construction bid document addendum 01

project: Southern Maine Community College - Horticulture Greenhouse
Midcoast Campus, Brunswick, Maine BGS # 3674

date: 12 November 2024

A20

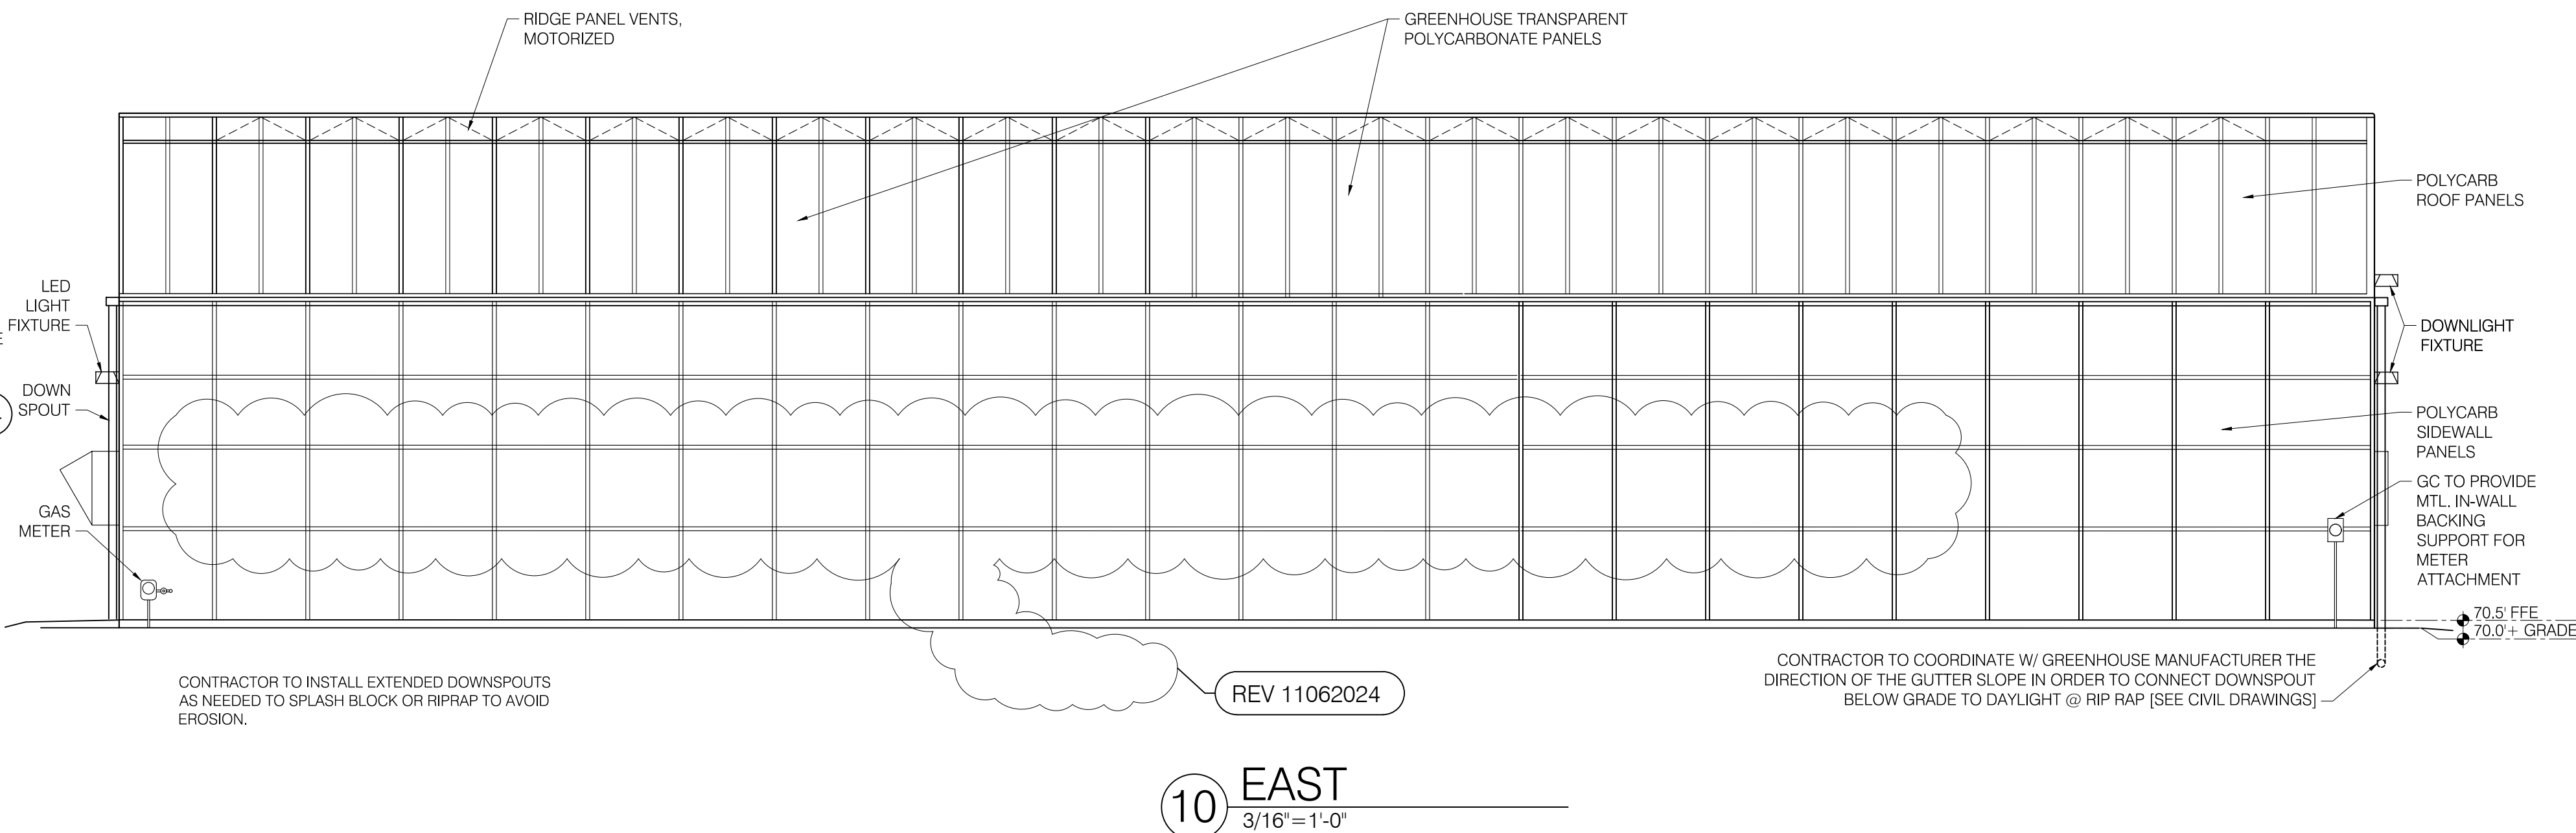
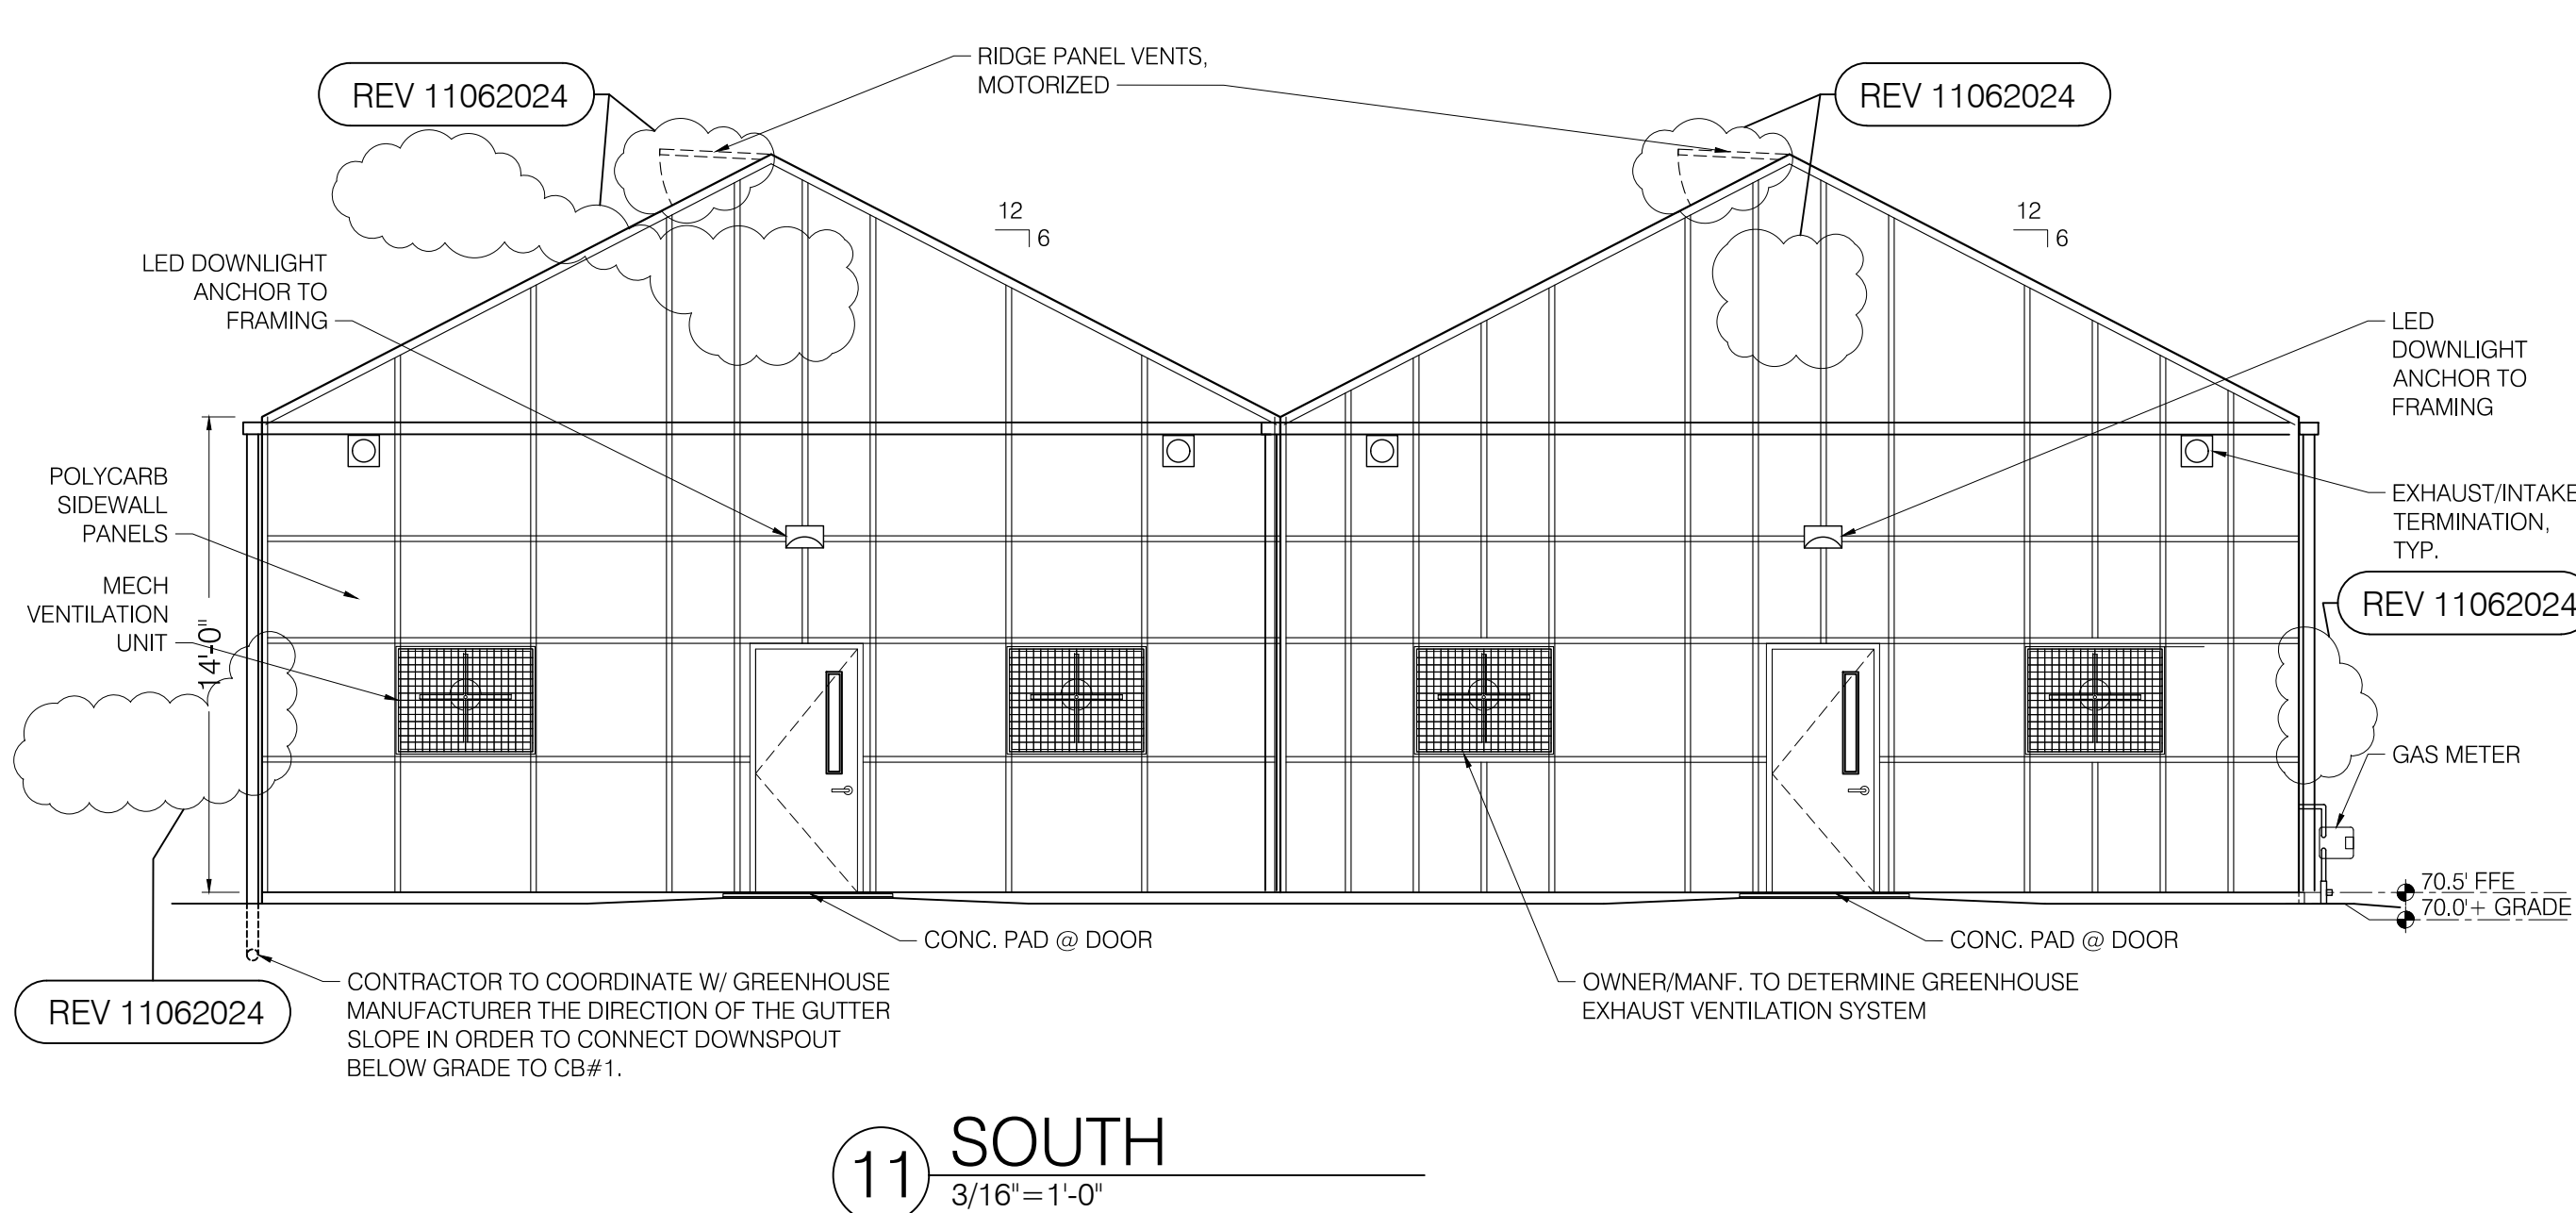
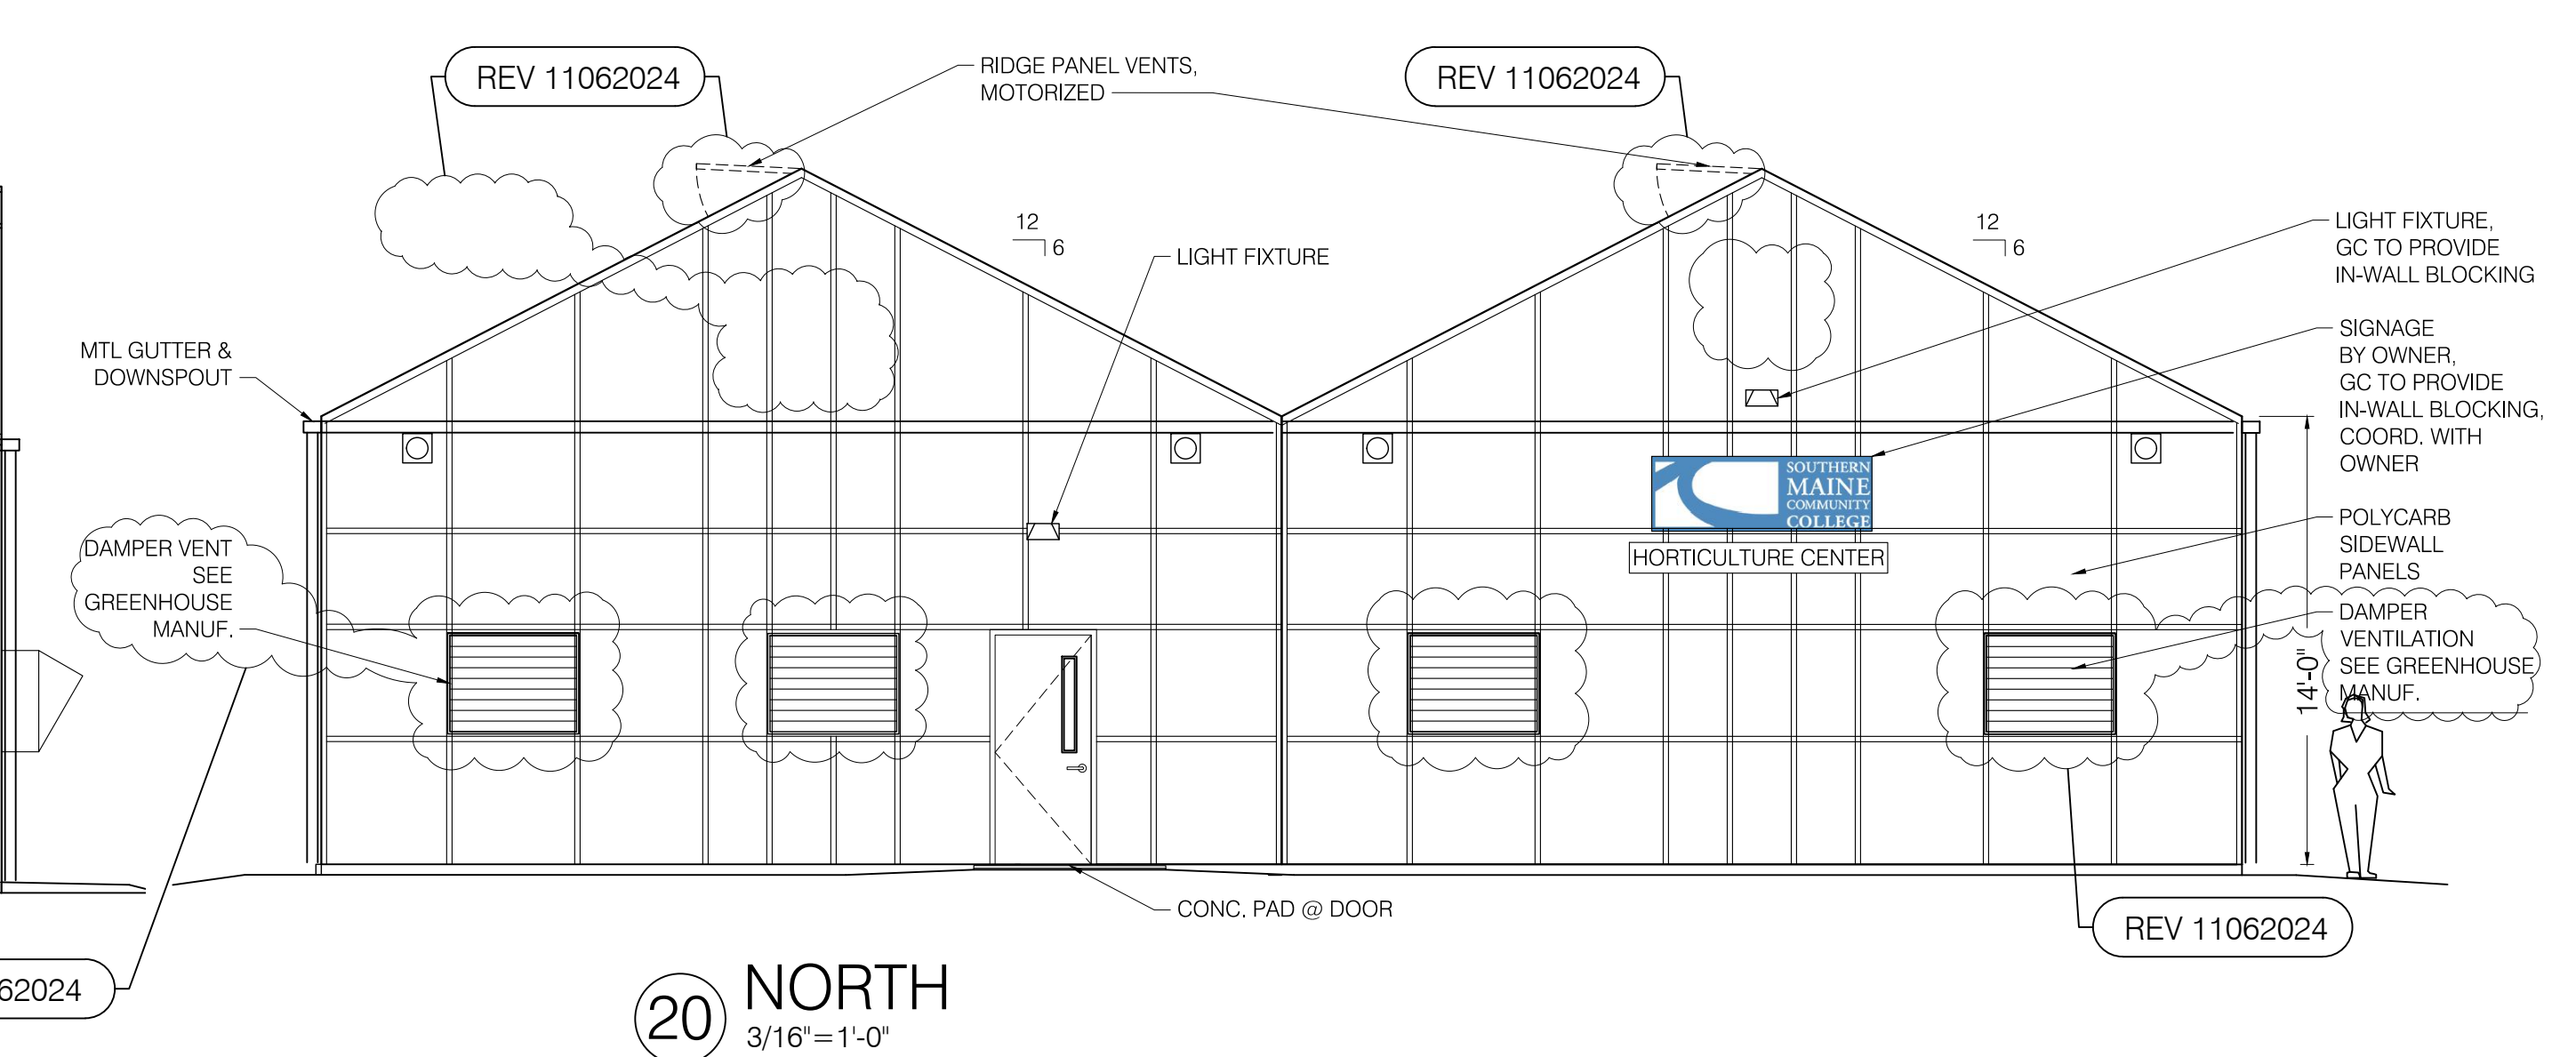
9. **Ventilation system.** Revisions as follows and as noted on attached drawings.
OMIT: West side of motorized gull-wing ridge vent. Maintain east side of motorized ridge vent on both bays.
OMIT: Manually operated wall ventilation.
OMIT: South elevation upper exhaust fans. Maintain (2) two lower exhaust fans on both bays per Greenhouse manufacturers sizing and specifications.
OMIT: North elevation upper intake dampers. Maintain (2) two lower intake dampers on both bays per Greenhouse manufacturers sizing and specifications.

A20 EXTERIOR ELEVATIONS: Wall ventilation removed, ridge ventilation revised and exhaust fans and dampers revised.
